SERVICE BULLETIN No. 23___SKY INTERNATIONAL INC.

AIRCRAFT: Husky A-1B's equipped with Lycoming O-360A1P engines.

To notify the above specified Husky aircraft owners that the alternator on their aircraft possibly has a shroud that needs to be removed.

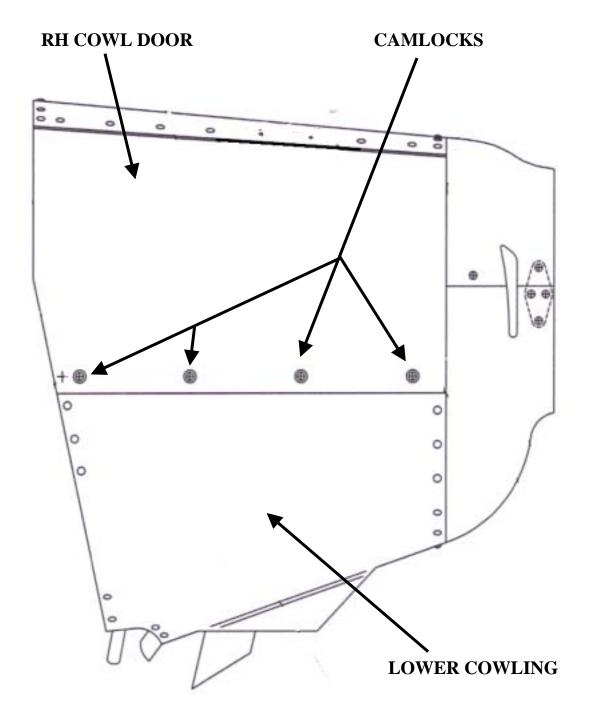
- 1- Disconnect Battery.
- 2- Undo 4 camlocks on both cowl doors and lift up doors. (Figure 1)
- 3- Remove lower cowl. (Figure 1)
- 4- Loosen clamp on scat hose. (Figure 2)
- 5- Push scat hose with clamp attached out of the way. (Figure 2)
- 6- Shroud is attached to back of alternator with 4 screws. Remove 4 screws and shroud. It is not necessary to remove any wires. (Figure 2)
- 7- Reattach scat hose and tighten clamp.
- 8- Reinstall lower cowling.
- 9- Close doors and lock shut with camlocks.
- 10- Hook battery back up.
- 11- Document compliance to service bulletin in aircraft logbook and complete compliance letter instructions and submit.

FIGURE 2

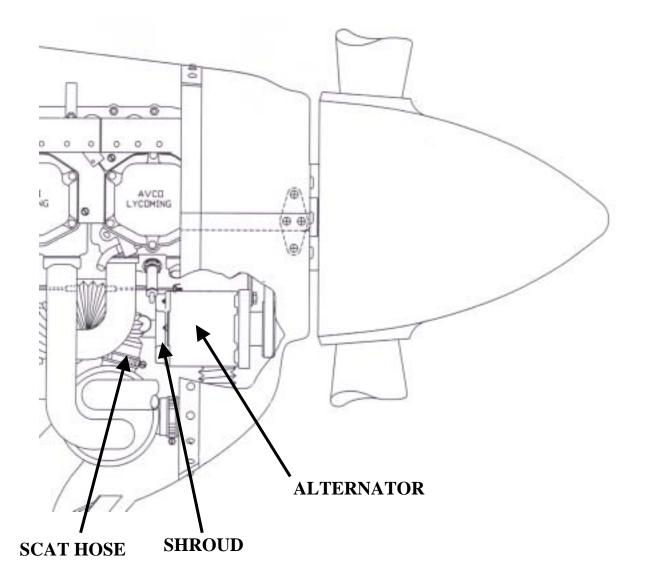
- 1- Inspect aircraft and verify installed alternator model.
- 2- Aircraft equipped with ALX8521LS alternator with a cooling shroud installed on the rear of the alternator requires the cooling shroud be removed (See page 4, Figure 2 for cooling shroud location). To remove cooling shroud follow Accomplishment Instructions below.
- 3- Aircraft equipped with alternators ALX6521LS-1 or ALY8520LS requires completion and submittal of compliance letter only. (See Page 5).
